# Access Compliance Report

## Public Rights-of-Way

Intersection ID: 45510	Main Street: WOODLAND_WATCH_CT	Cross Street: MEADOW_BOTTOM_RD	Location: SE
ADA ID: 5E35C90458BB	Ramp Type: PerpDiag	Initial Pass/Fail: Fail	Overall Compliance: No
Severity Score: 13.75			
Codes/Mitigation Info/Possible Solution		Field Measurements/Component Compliance

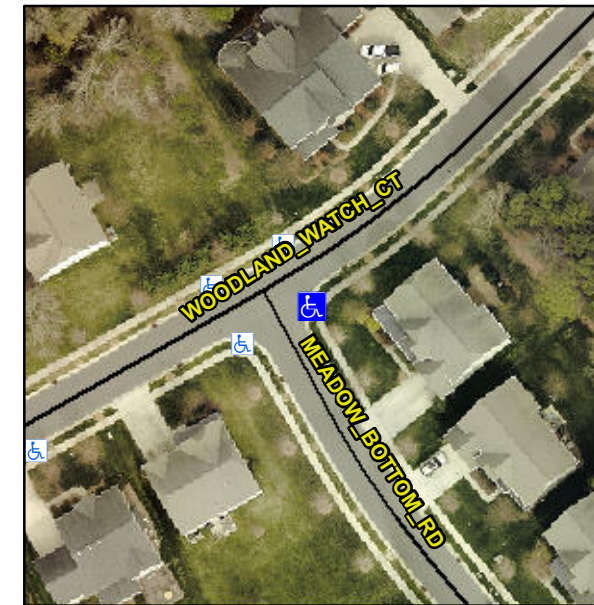
**Not Found, R304.2.2, R304.5.3**

Compliance	Description	Data	Compliance	Description	Data
N/A	Ramp Length (in)	48.0	No	Ramp Slope (%)	10.2
Yes	Ramp Width (in)	48.0	No	Ramp XSlope (%)	2.5
N/A	Flare Type LT	N/A	N/A	Flare Type RT	N/A
N/A	Flare Slope LT (%)	N/A	N/A	Flare Slope RT (%)	N/A
N/A	Flare Traversable LT?	N/A	N/A	Flare Traversable RT?	N/A
N/A	Landing Length (in)	N/A	N/A	DWS Provided?	N/A
N/A	Landing Width (in)	N/A	N/A	DWS Contrast?	N/A
N/A	Landing Slope (%)	N/A	N/A	DWS Length (in)	N/A
N/A	Landing X Slope (%)	N/A	N/A	DWS Full Width?	N/A
N/A	Landing Curb? (Y/N)	N/A	N/A	DWS Offset (in)	N/A
N/A	Shared Landing?	N/A			
N/A	Gutter Ponding?	N/A	N/A	Gutter Slope (%)	N/A
N/A	Gutter Lip Ht (in)	N/A	N/A	Gutter X Slope (%)	N/A
N/A	Painted X Walk1?	No	N/A	Painted X Walk2?	No
	X Walk 1 Direction	To NW		X Walk 2 Direction	To SW
N/A	X Walk 1 Width (in)	N/A	N/A	X Walk 2 Width (in)	N/A
	X Walk 1 Slope (%)	3.7		X Walk 2 Slope (%)	0.7
	X Walk 1 X Slope (%)	1.2		X Walk 2 X Slope (%)	4.2

**Remove & Replace Curb Ramp With Two New Directional Ramps or Equivalent.**
